K2000 Modification List

Changes for the K2000

K2500 Modification List

Subject: Oscillation in 5v power supply caused by a KF351 comparator in +5 volt regulator circuit.

DIFFERENCE BETWEEN FATAR MD & MDF KEYS

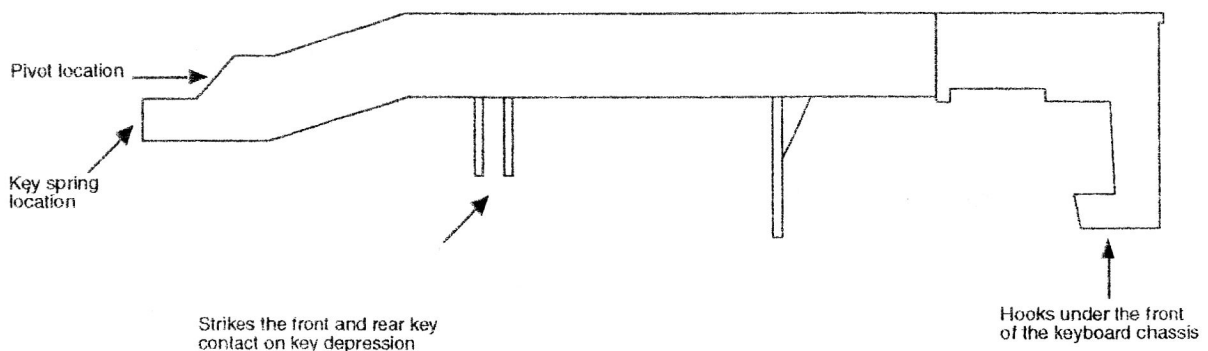
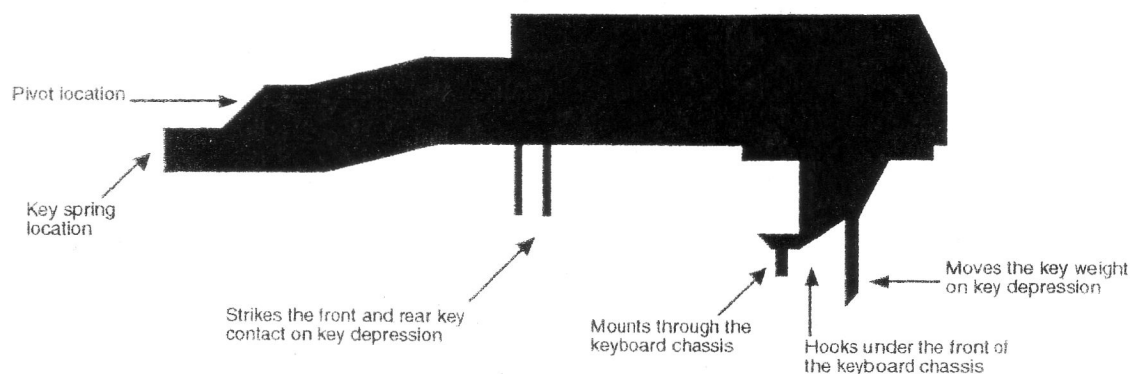
- Generally you will find keyboards produced after April of 1998 to have the MDF style keys and weights.
- When ordering a key or keyweight from Kurzweil you should always have the serial number of the keyboard handy for verification.

DIFFERENCE BETWEEN FATAR MD & MDF SHARP KEYS

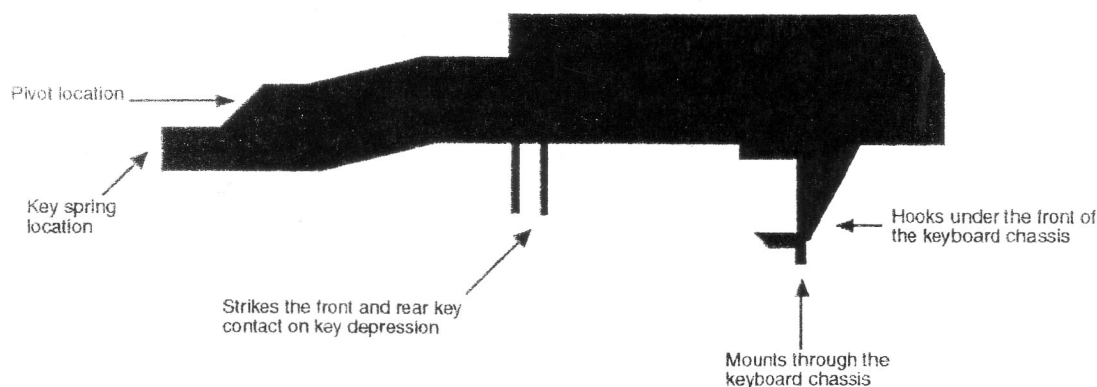
- Generally you will find keyboards produced after April of 1998 to have the MDF style keys and weights.
- When ordering a key or keyweight from Kurzweil you should always have the serial number of the keyboard handy for verification.

DIFFERENCE BETWEEN FATAR MD & MDF KEYS WEIGHTS

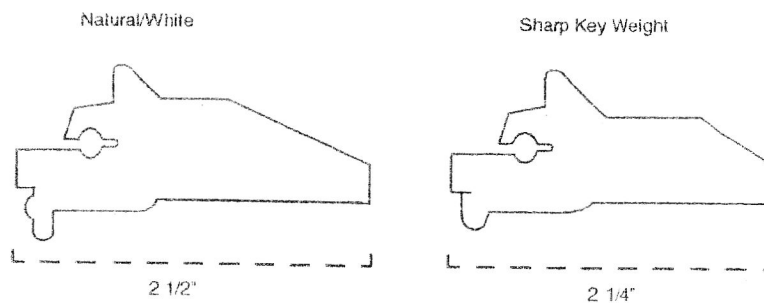
- Generally you will find keyboards produced after April of 1998 to have the MDF style keys and weights.
- When ordering a key or keyweight from Kurzweil you should always have the serial number of the keyboard handy for verification.
